**BHP Mitsubishi Alliance**

# **Appendix J**

## **Request for Information Response**

# Caval Ridge Mine: Horse Pit Extension Project Request for Information Addendum

**Figure 3-1 Horse Pit Extension**

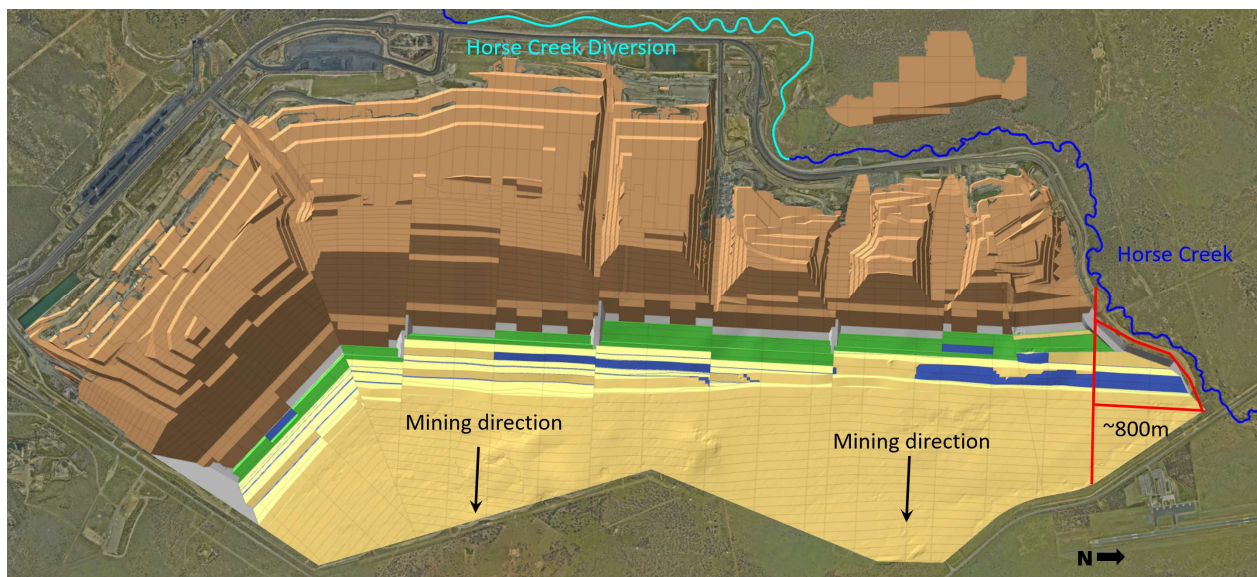
*Requested Action 4: Provide further details of why an out of pit dump is a required option, if proposed.*

An OOPD is proposed in order to provide the dump capacity required to mine the Project.

The Project (Figure 3-1) will continue mining to the east and is earmarked to commence in 2032 (as per current schedules). The northern most component of Horse Pit extends by ~800m (highlighted in Figure 3-2 below) and is limited to within a distance of Horse Creek. In a lead up to start of extension (2032) until the end of mine life, this northern extent is associated with a substantial increase in mining intensity. This is due to progressive closure of Heyford Pit at this time and due to the southern end of Horse Pit being already at capacity at that point in time. This places significant pressure on spoil balance and supports requirement of an OOPD on top of other dumping options already in place.

Standard mining practice includes allowance for ~ 25% buffer for dump capacity. The proposed approach described above, steadily decreases the available dump room down to ~2% of cumulative dig volumes.

**Figure 4-1 Set-back to  $FoS \geq 1.5$**

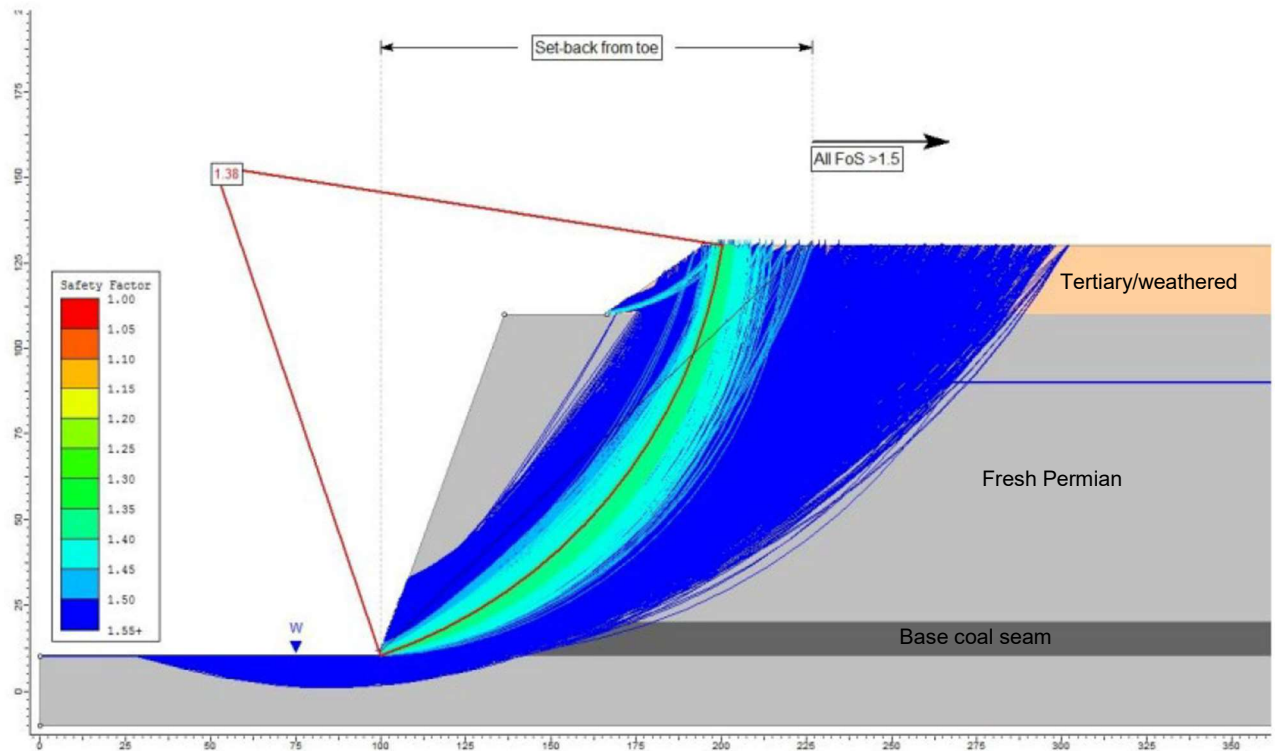
***Requested Action 5:** Given the close proximity of the proposed highwall to the Peak Downs Highway and the Moranbah Access Road as well as to the township of Moranbah, provide a geotechnical report of the final design of the highwall which includes the following:*

Limit equilibrium has been used to geotechnically assess the highwall of Horse Pit. Limit equilibrium is currently accepted by industry as the most practical method available. It compares forces on a surface with (limiting) strength if it was at the point of failing. Defects may be included explicitly as discrete strata when known, but more often are implicit within the strengths of broader material layers.

The final void is designed with the required highwall set-back to achieve a minimum factor of safety (FoS) of 1.5 at the mining lease, the Peak Downs Highway corridor and the Moranbah Access Road corridor. This is illustrated in Figure 4-1. This figure is simplified to show the overall wall angles within the Tertiary, weathered Permian and fresh Permian material. A minimum FoS of 1.5 is generally adopted for long-term stability of civil engineering features which have broad public access, such as road cuttings and dam walls.

**Figure 10-4 HPE Monitoring Network**

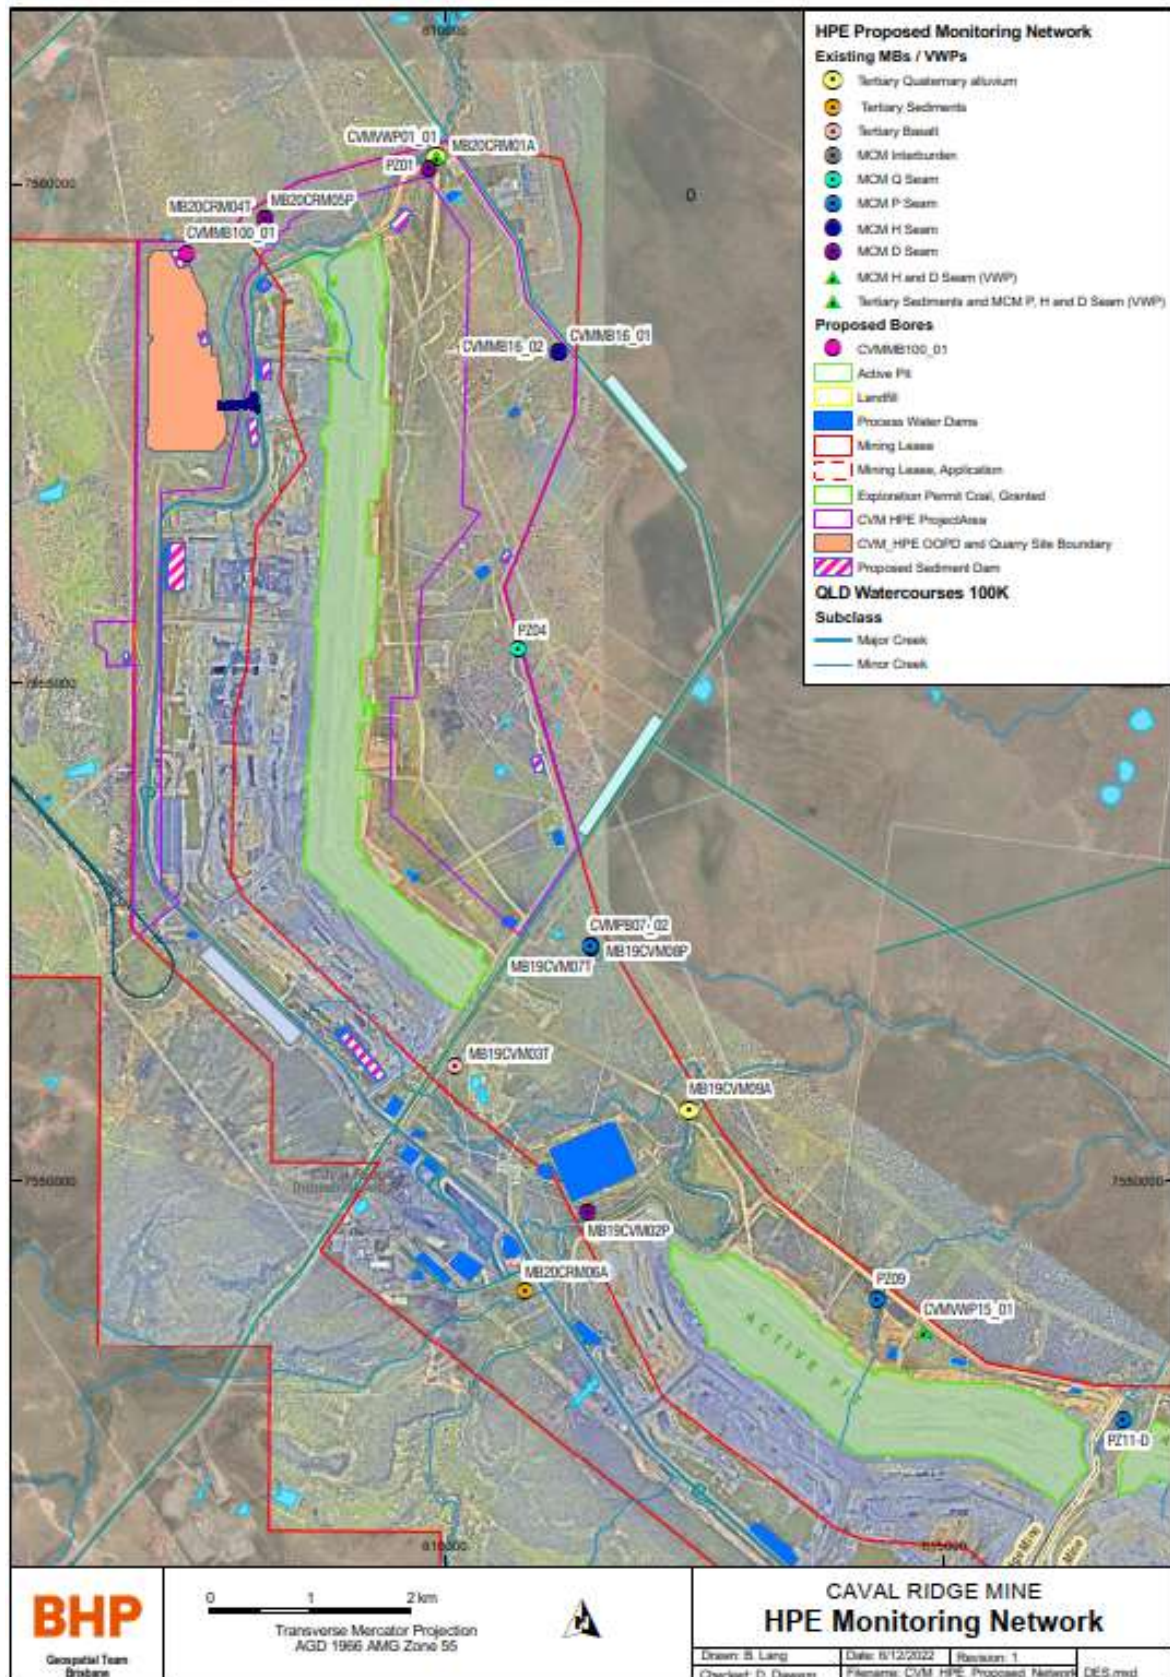
*Figure 8-1 of Appendix F indicates that the groundwater monitoring bores of the proposed monitoring network are within the pit extent of the extension project. Additionally, there is a lack of bores on the western side of the mine for identification of upgradient concentrations.*

The following section describes the monitoring infrastructure proposed to monitor predicted Project impacts. 19 monitoring bores (18 existing and 1 proposed) and two (2) VWP sensor arrays have been nominated in up and downgradient locations across the Project Area. Proposed monitoring infrastructure detail and rationale are presented in Table 10-3 with locations displayed in Figure 10-4.
